WATER QUALITY MEMORANDUM

Utah Coal Regulatory Program

RE: 2009 4th Quarter Water Monitoring, Canyon Fuel Company, Soldier Canyon Mine, C/007/0018, WQ09-4, Task ID #3440

TDS vs. Time

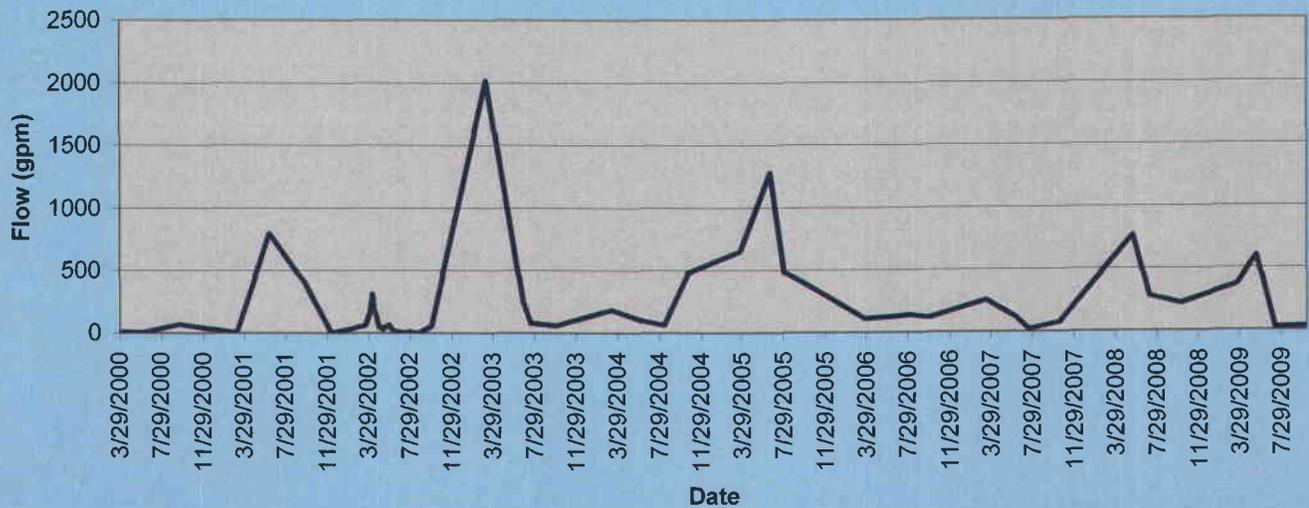
Site G-6- Total Dissolved Solids (TDS) and Total Cations (T-Cats) were reported outside of two standard deviations from the mean for this quarter.

For both sites, seasonal trends, as established by the data set, show an increase in TDS and associated components during the 3rd and 4th quarters of the year. However, the increases in these parameters for this quarter were higher than average. Continued monitoring will be conducted in order to establish what other than seasonal variation may have caused these increases. (See Charts Below).

TDS values for both G-5 and G-6 continue to trend well below the 3,000-mg/L value as established by Rule R317-2 Standards of Quality for Waters of the State. For this quarter, G-5 and G-6 produced TDS levels of 890 mg/L and 720 mg/L respectively

Continue to monitor trends in TDS and it's components.

G-5: D-Mg, Carbonate and SO4 vs. Time

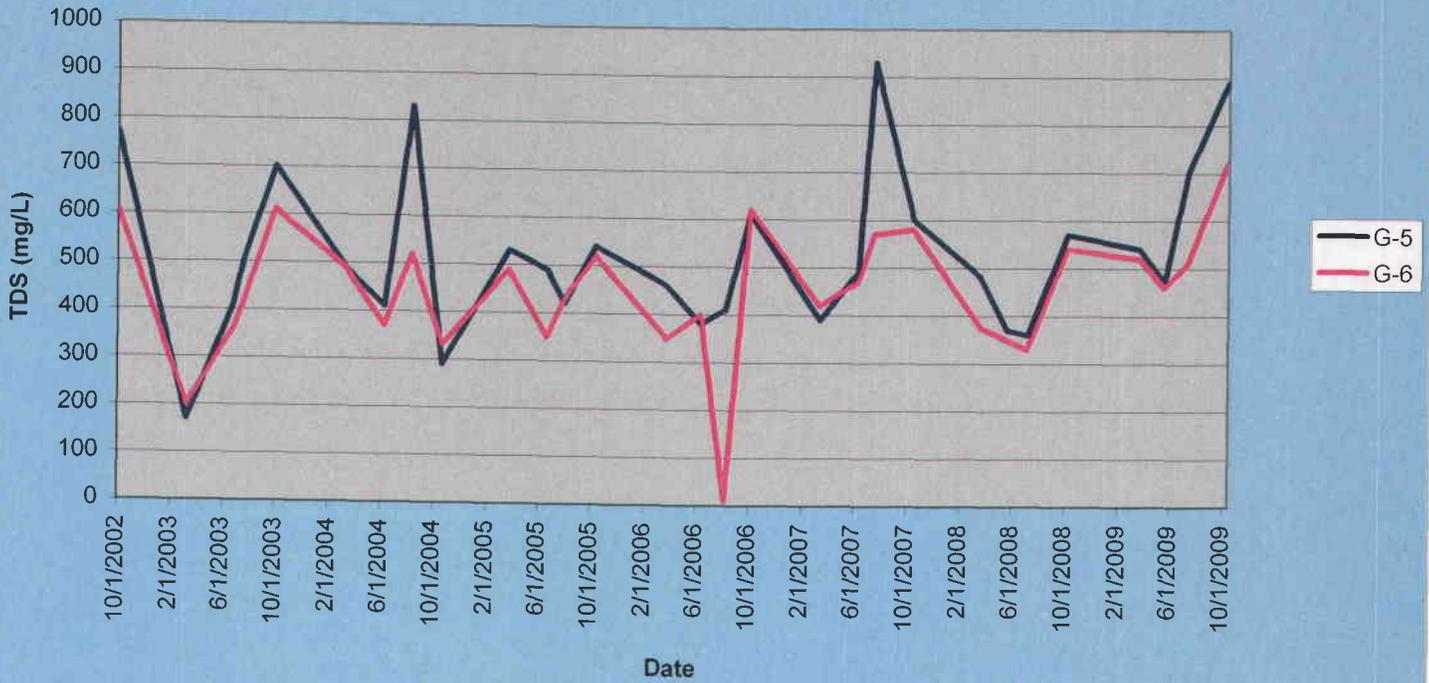
Site G-5- Dissolved Magnesium (D-Mg) and Sulfate (SO₄) were reported outside of two standard deviations from the mean for this quarter.
